NEBRASKA ARMY NATIONAL GUARD SIDNEY RC INTERIOR SUSTAINMENT

Sidney Readiness Center
2225 Legion Park Road
Sidney, NE 69162

PROJECT NO. 31030399

A D D E N D U M N O . 2

C1 FIRST FLOOR PLAN - HVAC

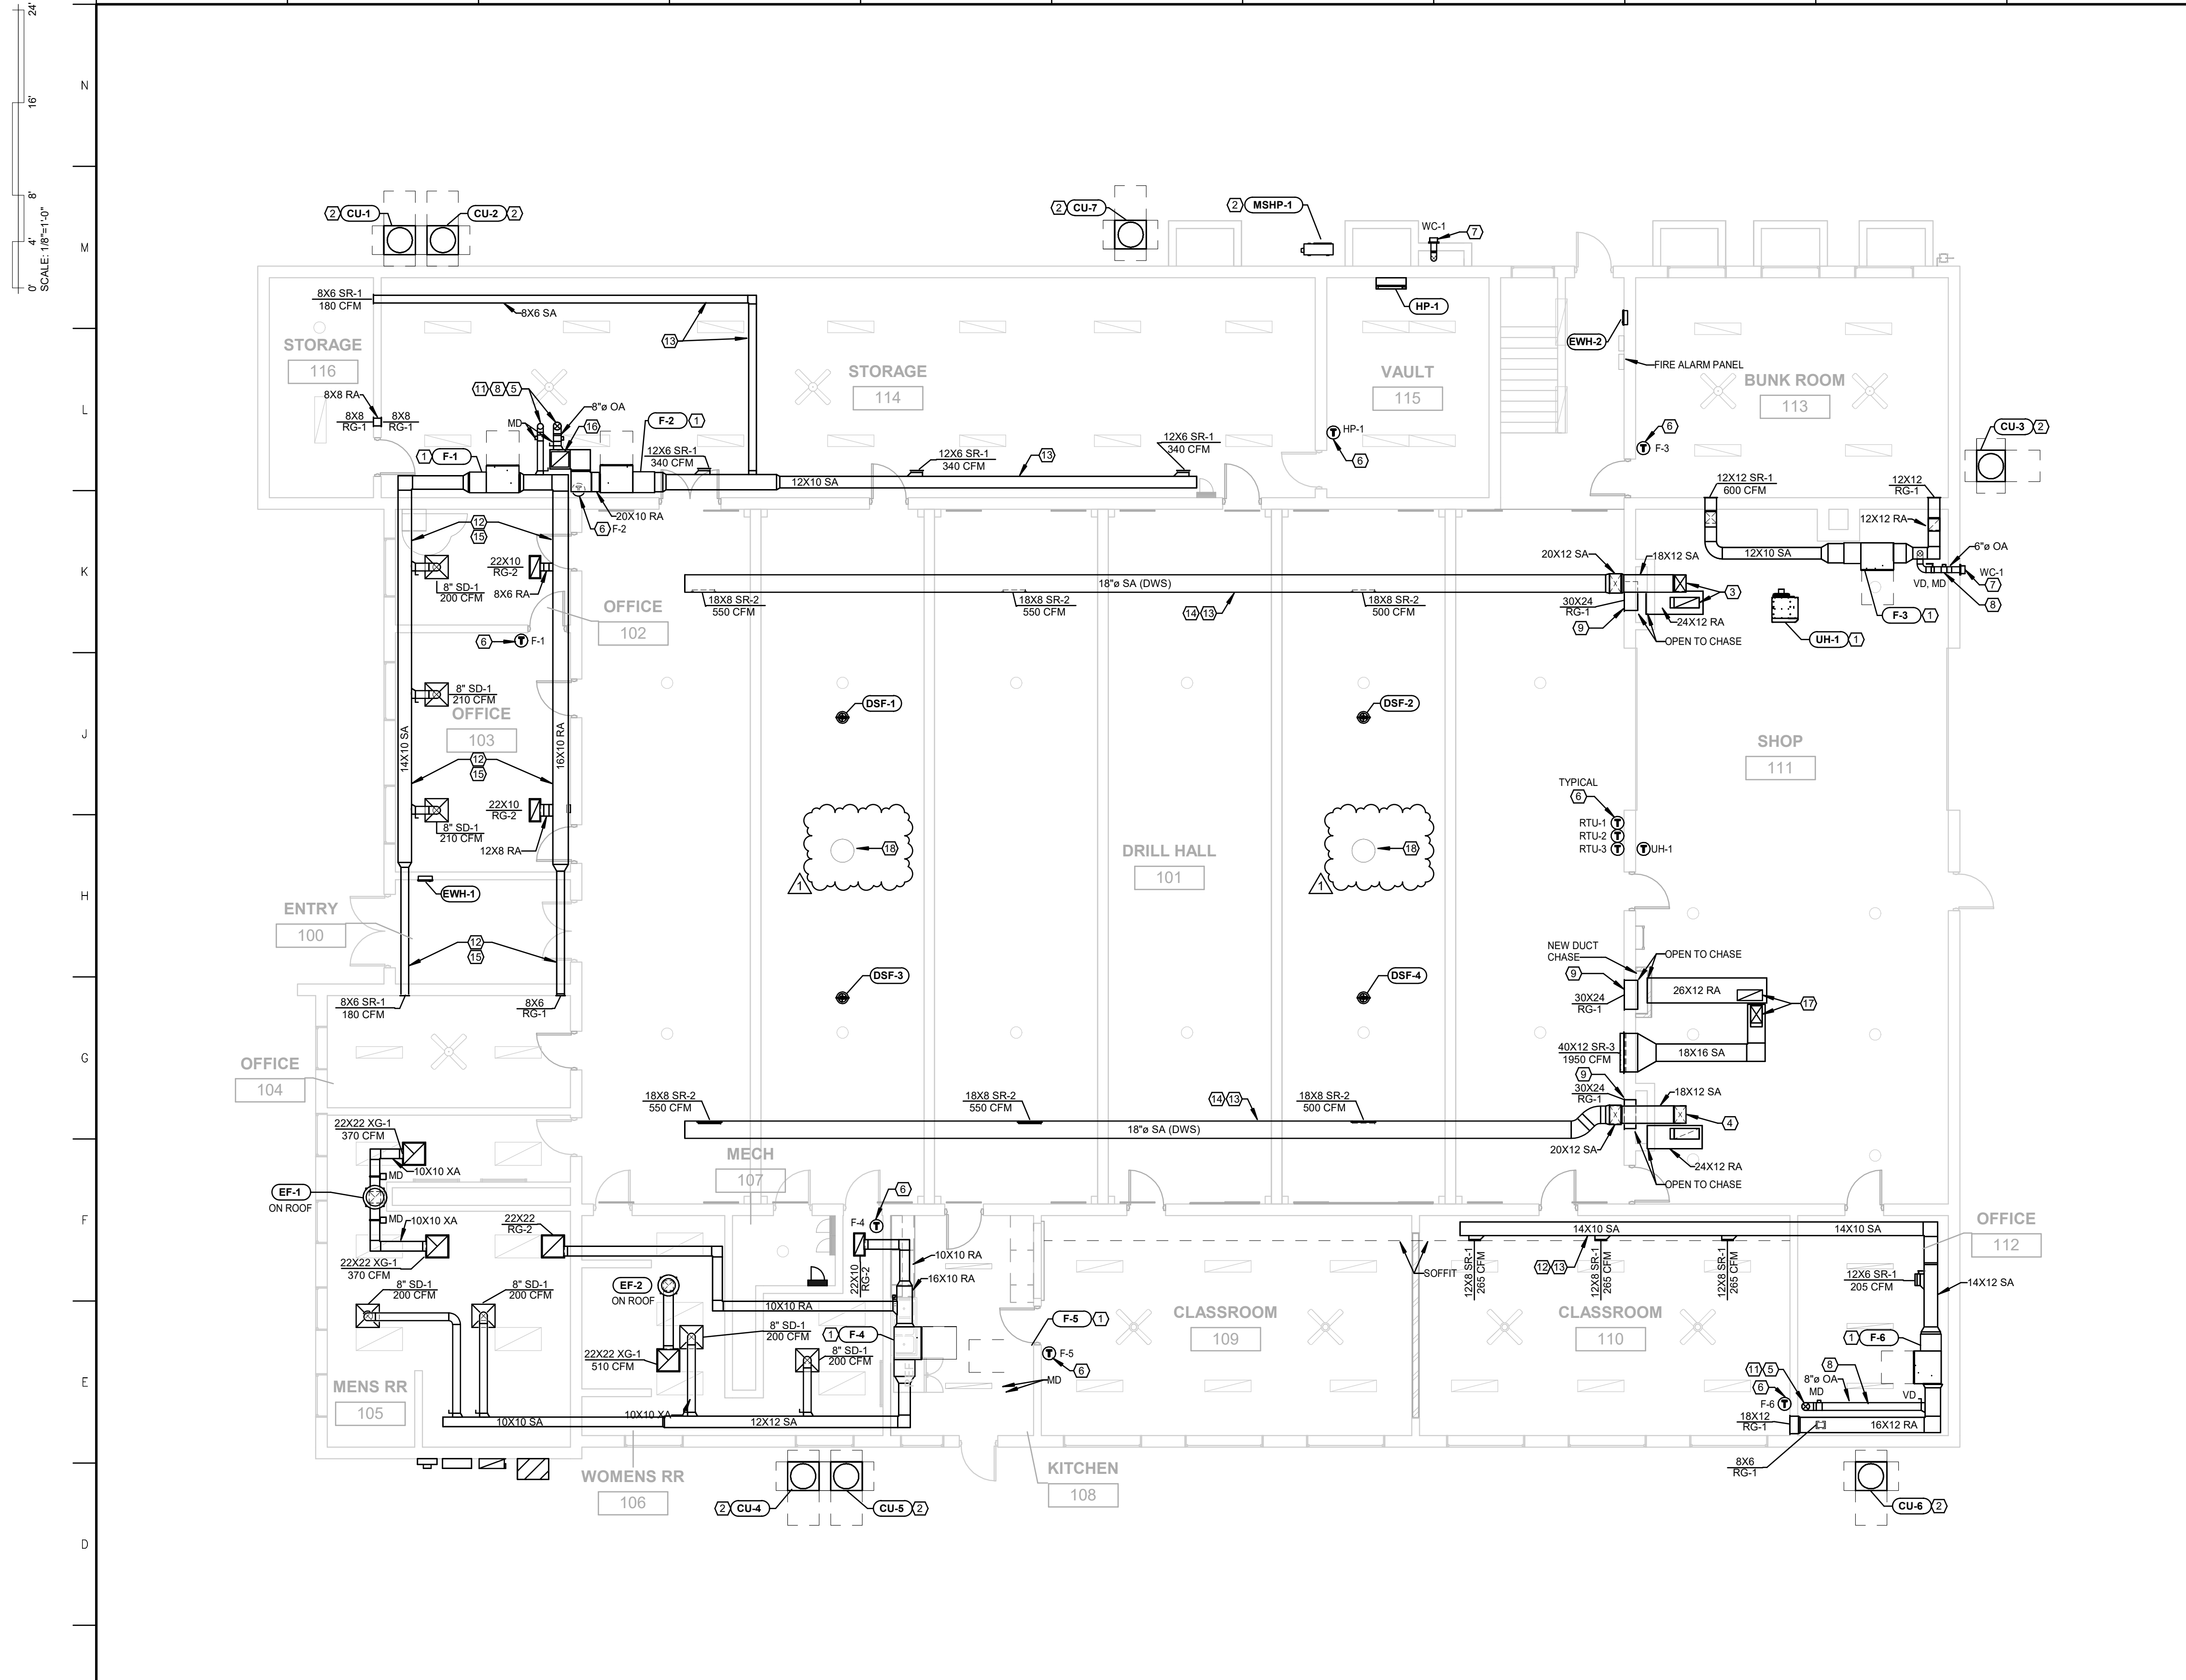
Sheet M103 – FIRST FLOOR PLAN – HVAC

- The two existing turbine ventilators located in the Drill Hall are to be capped to prevent air infiltration. See revised drawing for locations of ventilators and Keynote 18 for capping instructions.

A1 **SITE PLAN - ELECTRICAL**

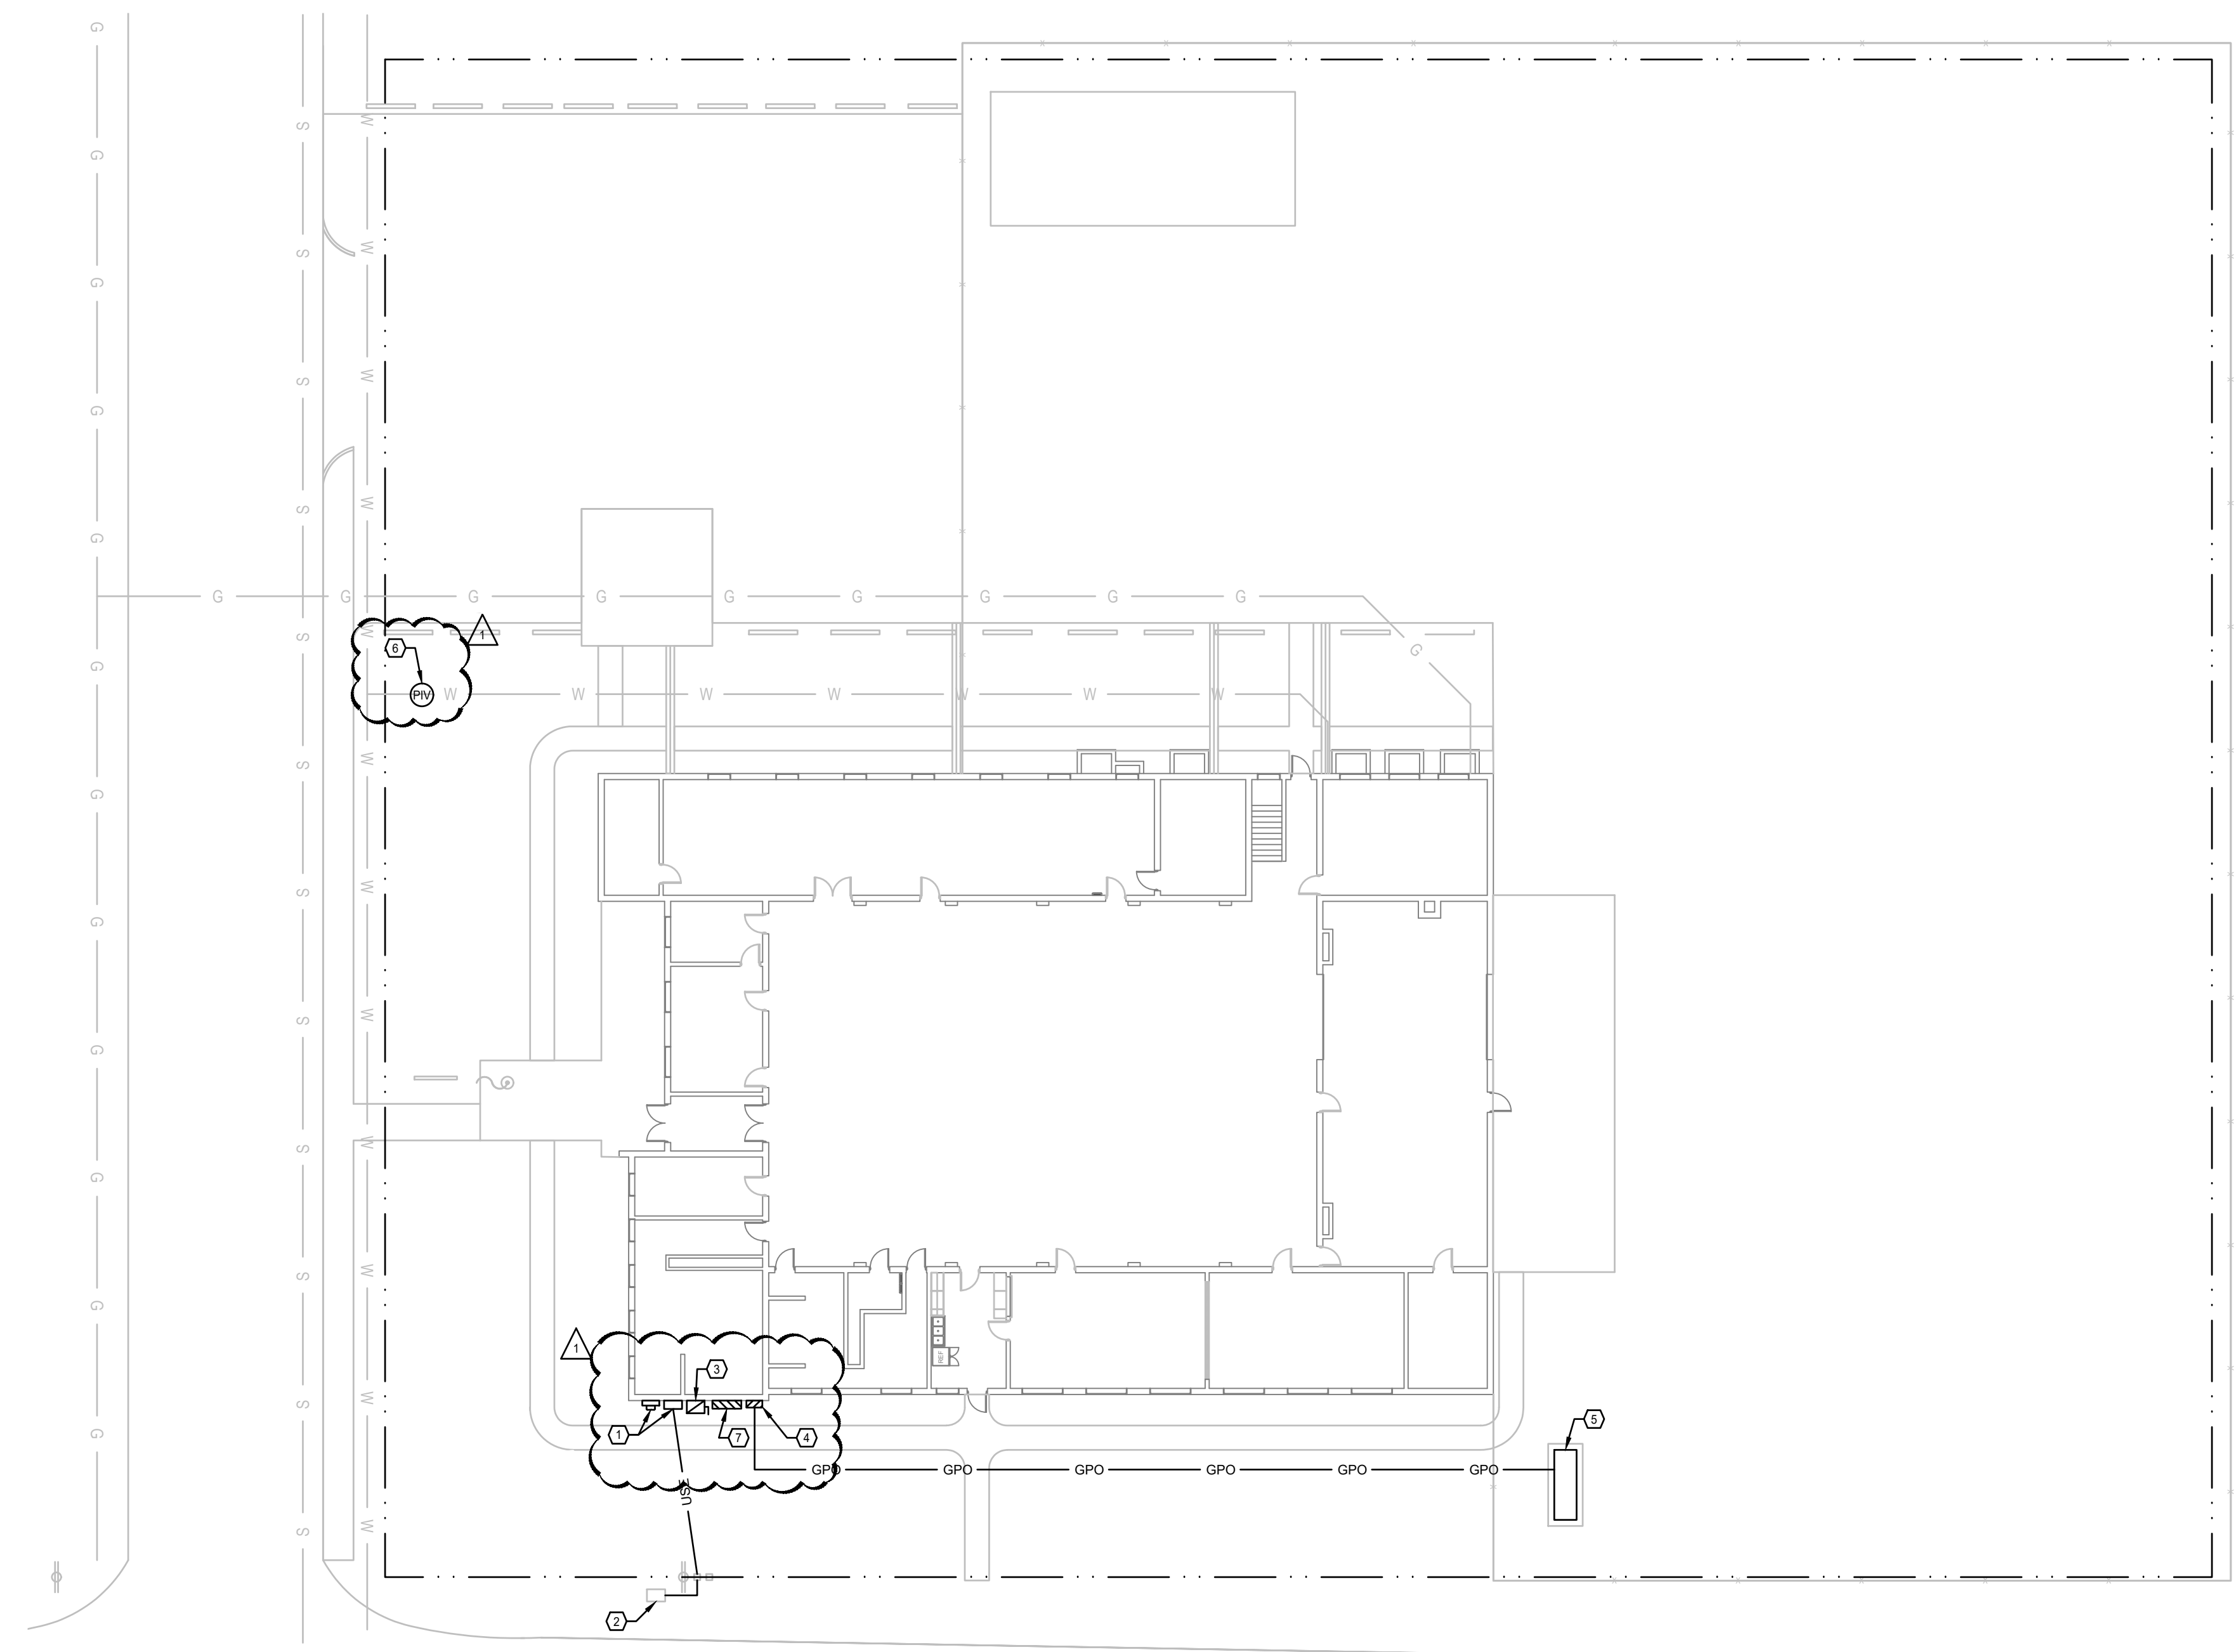
Sheet E001 – Site Plan - Electrical

1. Added PIV to site plan with Keynote 6.
2. Added Keynote 6 to read: "POST INDICATOR CALCE – PROVIDE WIRING IN 3/4" CONDUIT AND ROUTE UNDERGROUND TO FIRE ALARM CONTROL PANEL. VERIFY LOCATION WITH FIRE SPRINKLER CONTRACTOR."
3. Added MDP at service entrance location on exterior of building with Keynote 7.
4. Added Keynote 7 to read: "600A 120/240V I-LINE PANEL WITH LOCKABLE NEMA 3R ENCLOSURE."
5. Changed Keynote 4 to read: "400A 120/240V 3 POLE ATS."

DRAWING TITLE:
LOWER FLOOR PLAN - POWER

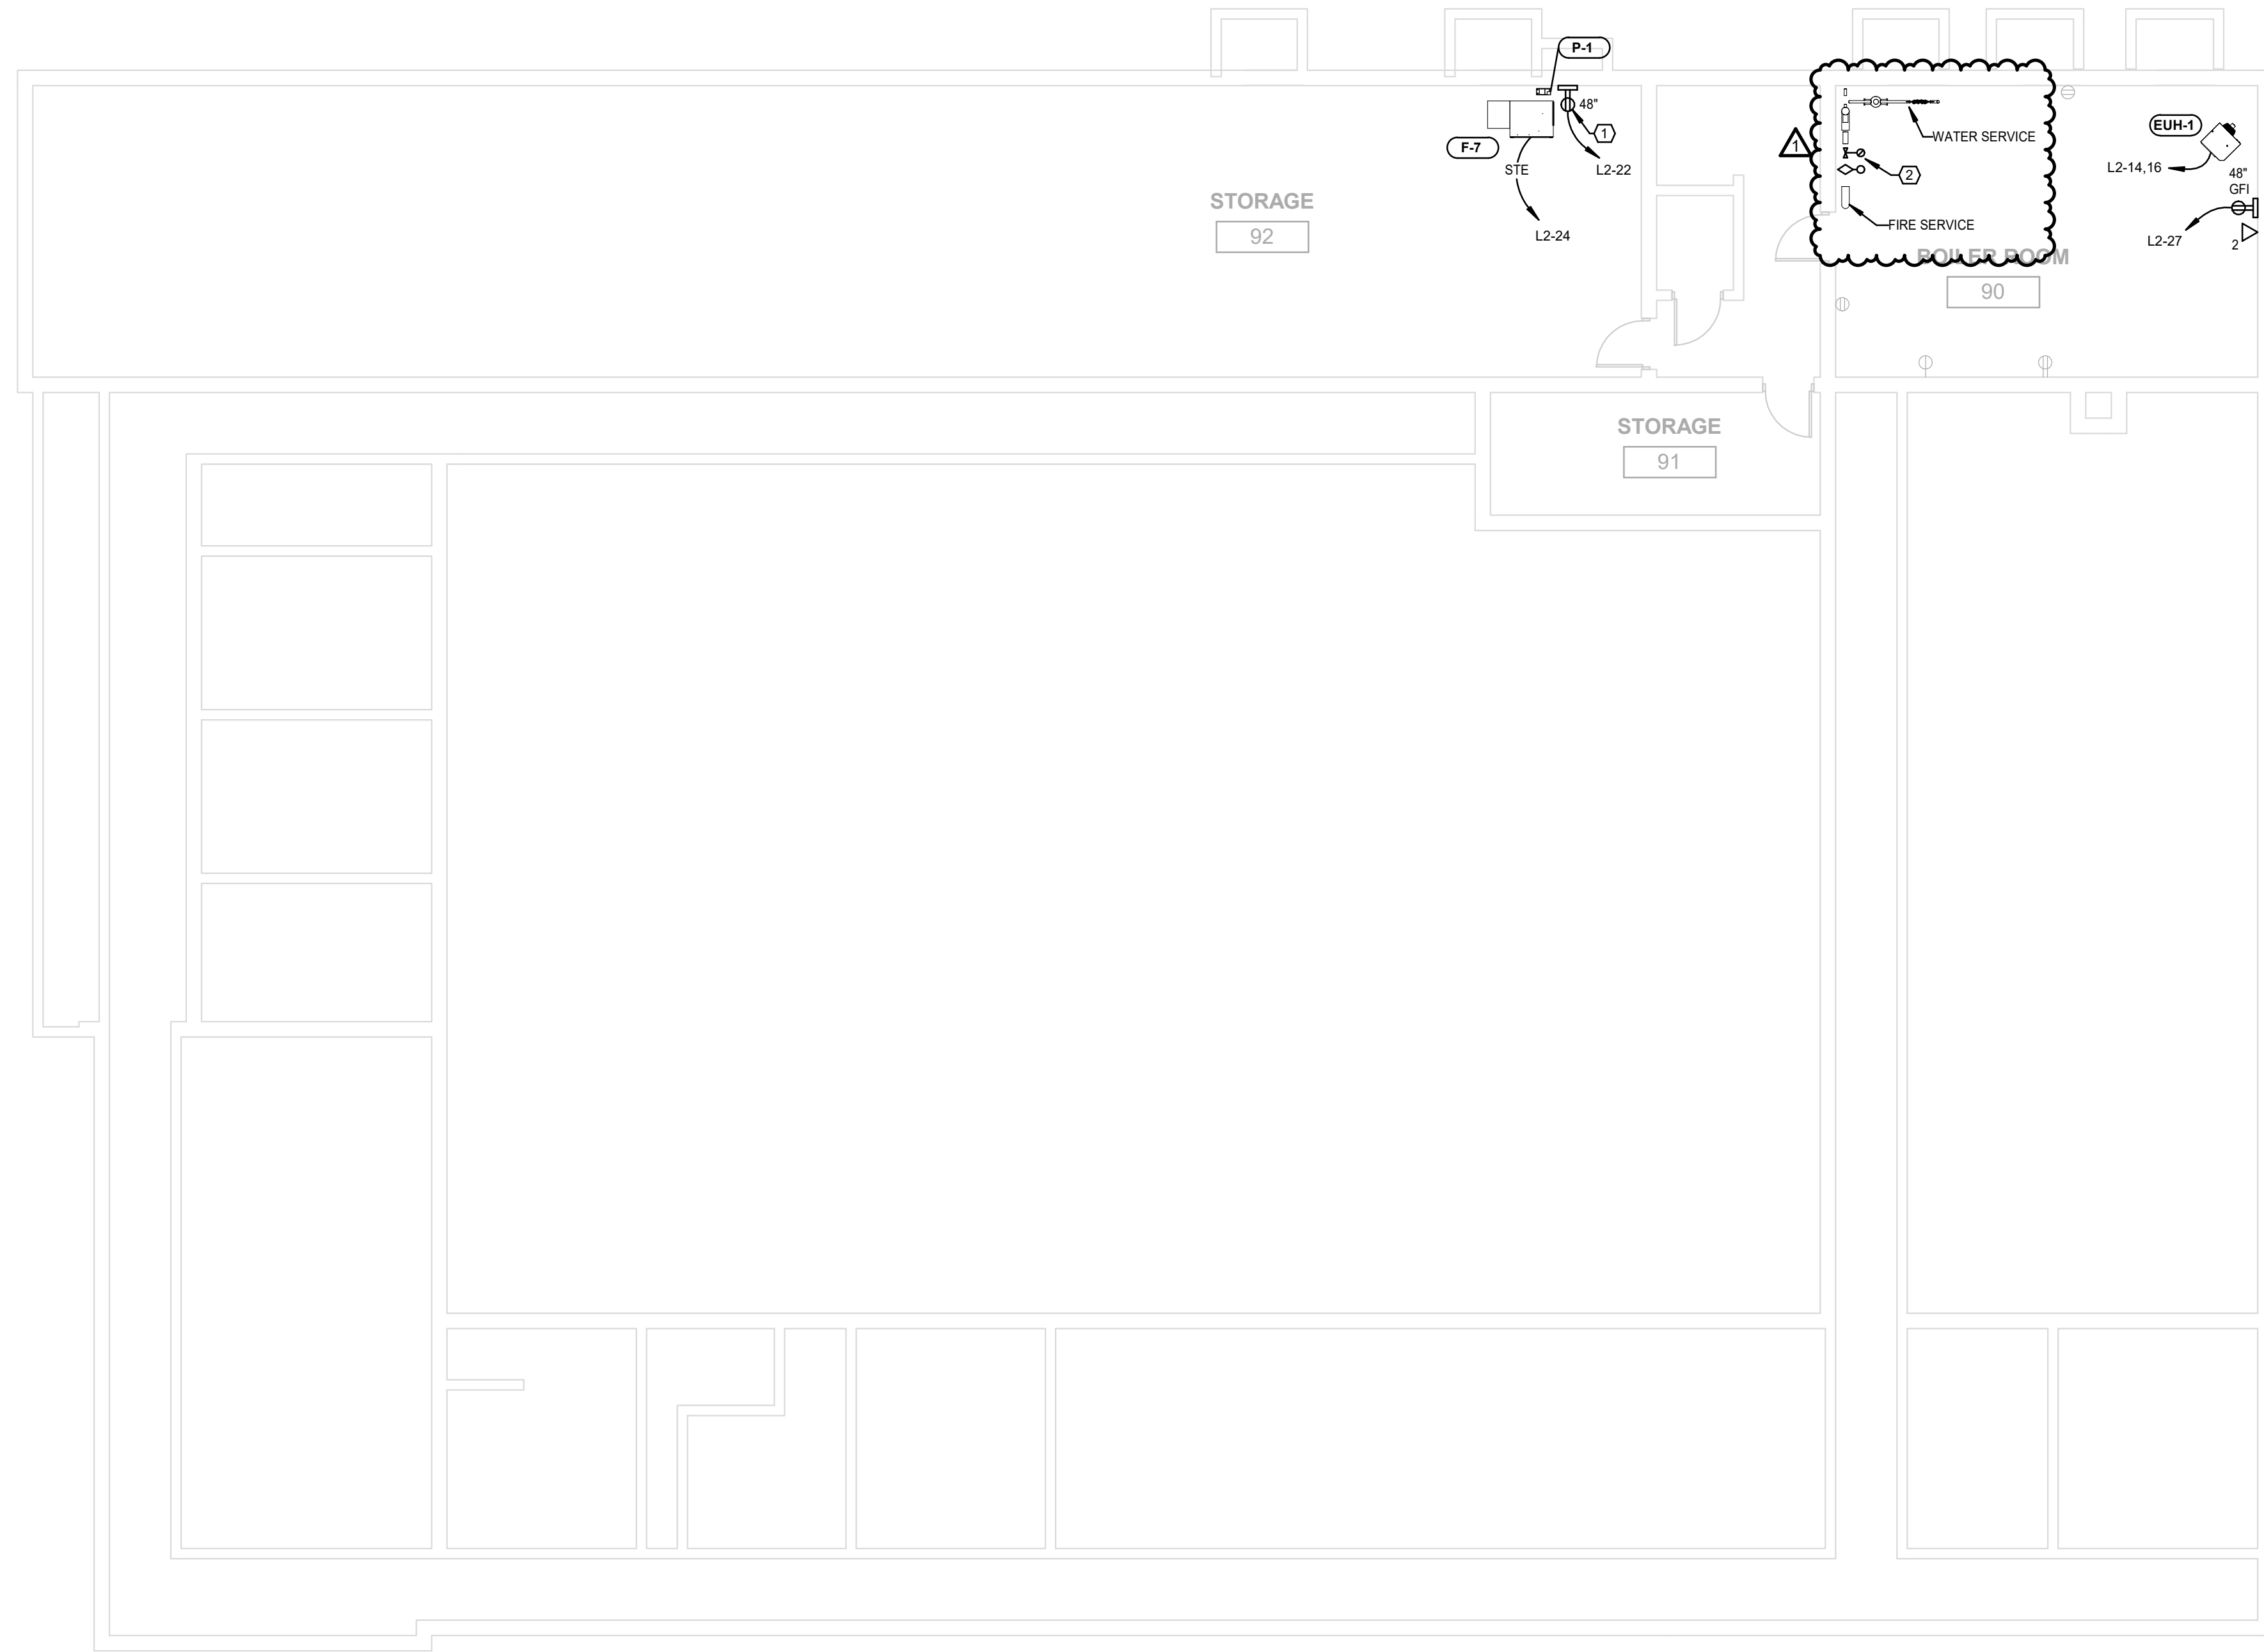
Sheet E201 – Lower Floor Plan - Power

1. Added tamper and flow switches to new fire service with Keynote 2.
2. Added Keynote to read: "CONNECT TAMPER/FLOW SWITCHES TO EXISTING FIRE ALARM SYSTEM."
